NEW YORK STATE DEPT OF ENVIRONMENTAL CONSERVATION ALBANY F/6 13/13
NATIONAL DAM SAFETY PROGRAM. WARNER DAM, CHAUTAUGUA LAKE OUTLET--ETC(U)
SEP 80 B L THOMSEN, G L WOOD

REPORT DOCUMENTATION PAGE		READ INSTRUCTIONS BEFORE COMPLETING FORM
1. REPORT NUMBER	2. GOVT ACCESSION NO.	3. RECIPIENT'S CATALOG NUMBER
	AD-A090 937	
4. TITLE (and Subtitle) Phase I Inspection Report Warrer Dam-Chautauqua Lake Outlet Allegheny River Basin, Chautauqua County, New York Inventory No. 750		5. TYPE OF REPORT & PERIOD COVERED Phase I Inspection Report National Dam Safety Program

7. AUTHOR(s) Bent L. Thomsen Gary L. Wood		6. PERFORMING ORG. REPORT NUMBER
9. PERFORMING ORGANIZATION NAME AND ADDRESS Thomsen Associates 105 Corona Avenue Groton, NY 13073		8. CONTRACT OR GRANT NUMBER(s) ✓ DACW-51-79-C-0001

A. Sheet 10, Subsheet 4.

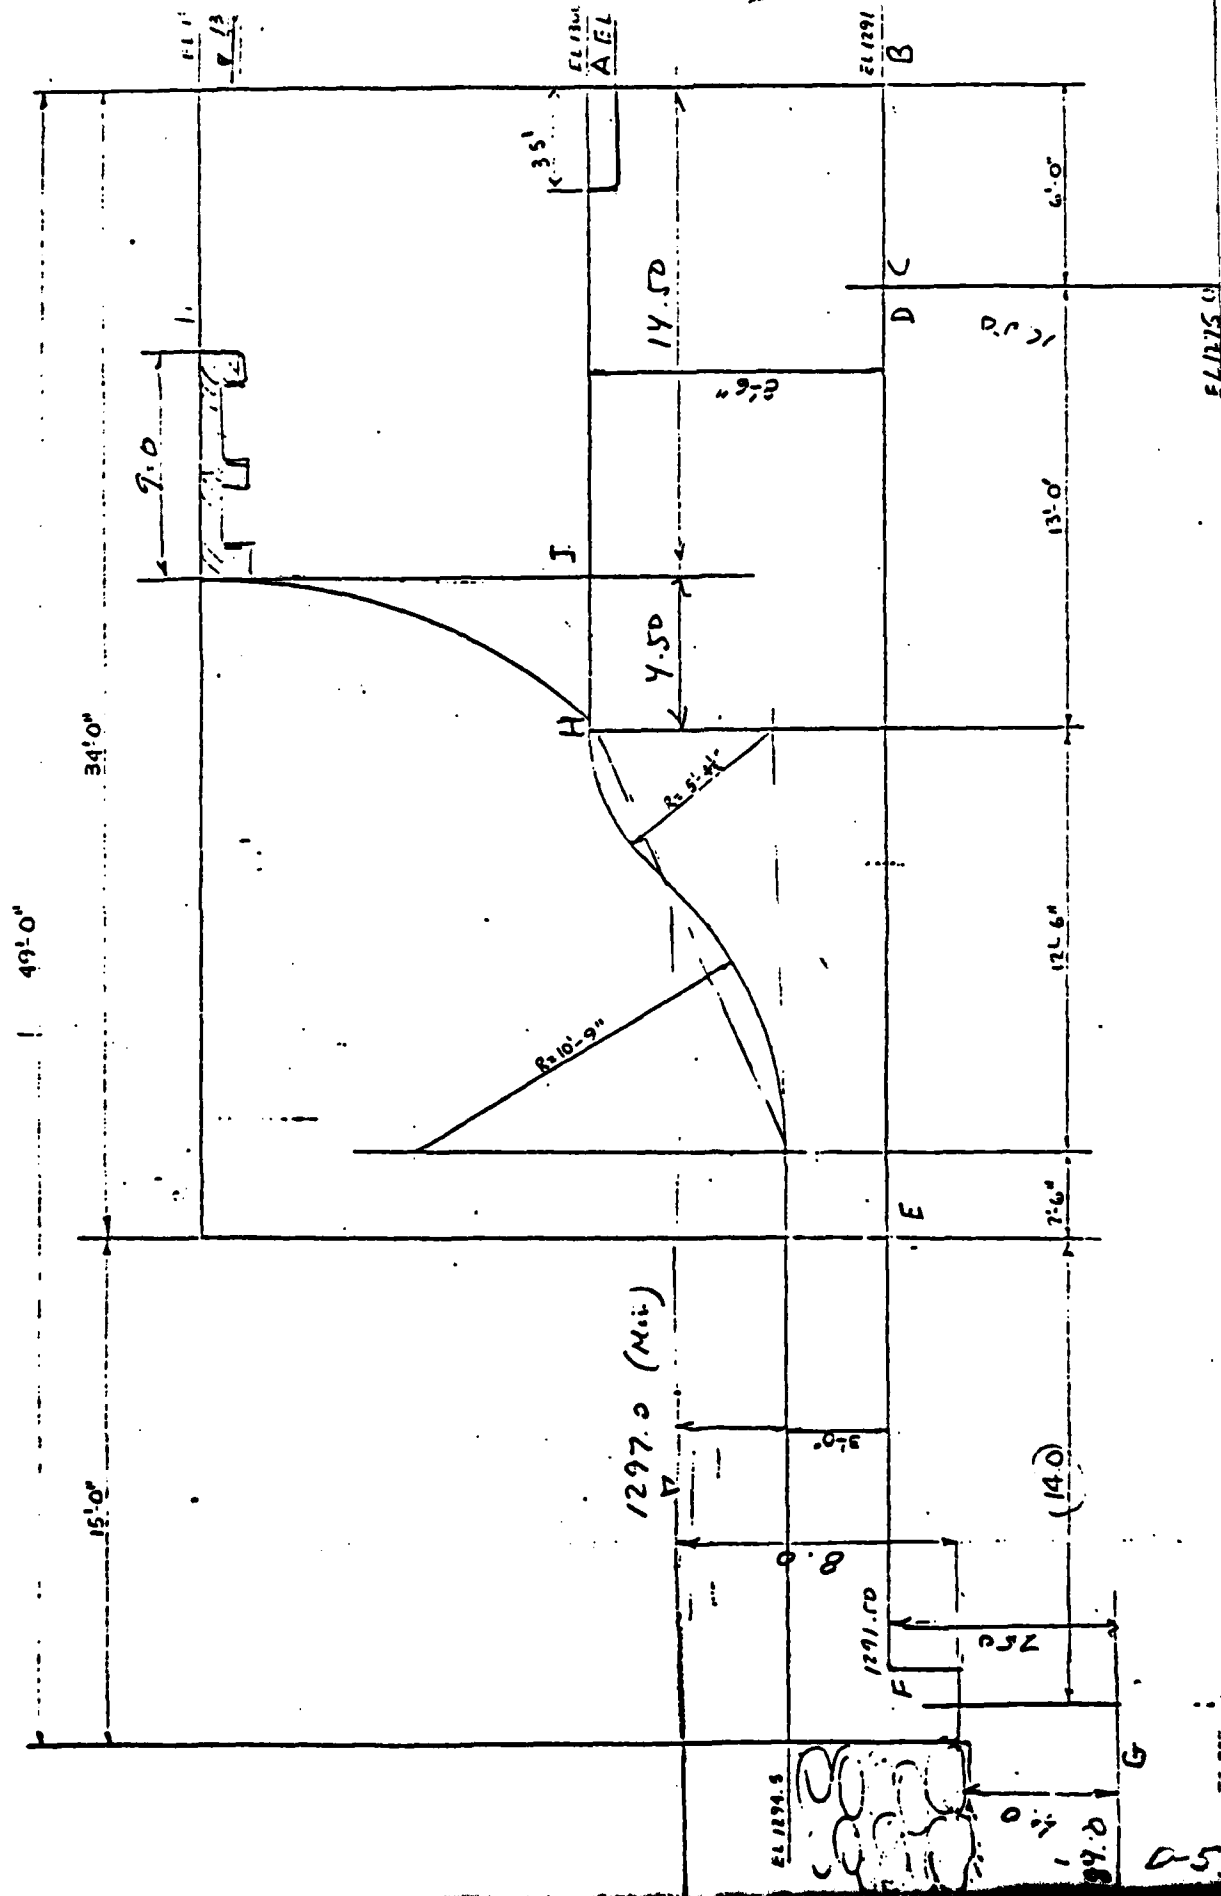
The weight of the concrete (214 kips) used in the additional vertical force computed for sliding stability is already included in the calculations from Sheet 9, Subsheet 3. (See Weight of Dam (2) near bottom of Subsheet 3). The correct additional vertical forces should read -99 kips rather than +115 kips, therefore, the resulting sliding S.F. should be 1.28 not 1.56.

B. Sheet 11, Subsheet 5

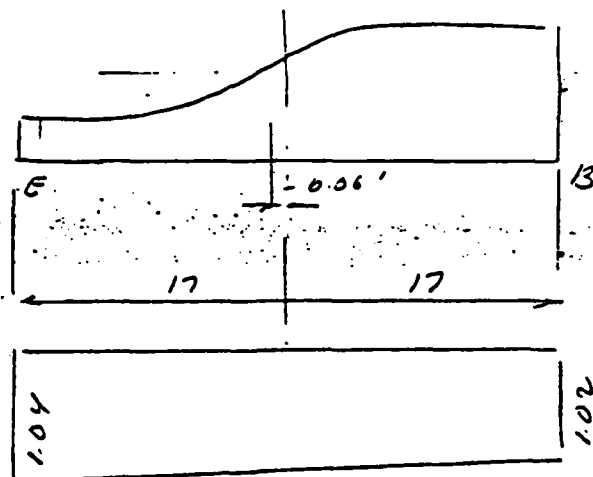
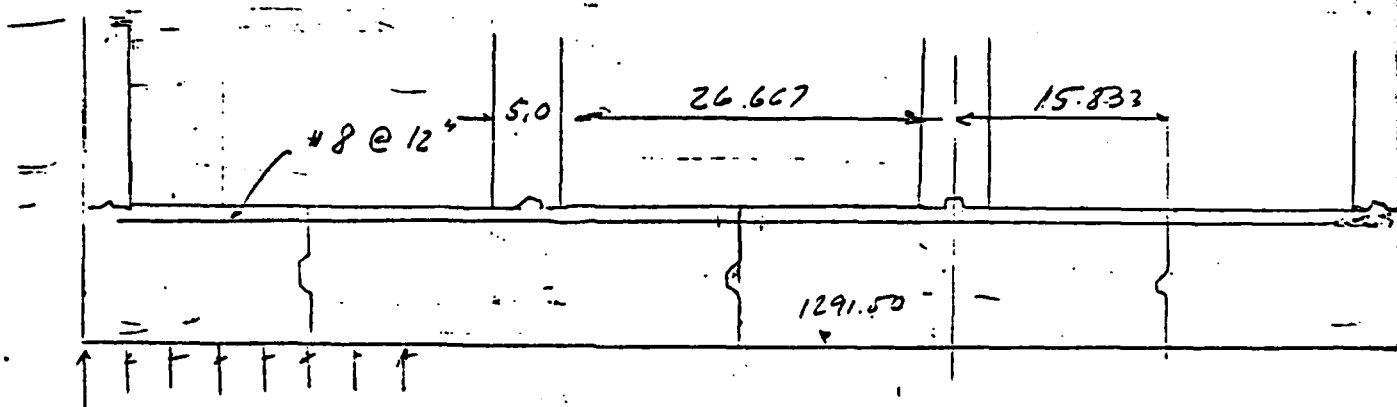
The computation of the total sum of moments acting on the dam between pt. B and pt. E is incorrect. This moment included the weight of the concrete between pt. E and point G (See Weight of Dam (2) and resulting moment near bottom of Subsheet 3). The correct total sum of moments should be reduced by 1350.0 kip-ft. This correction effects the calculated eccentricity, foundation pressure and internal stress.
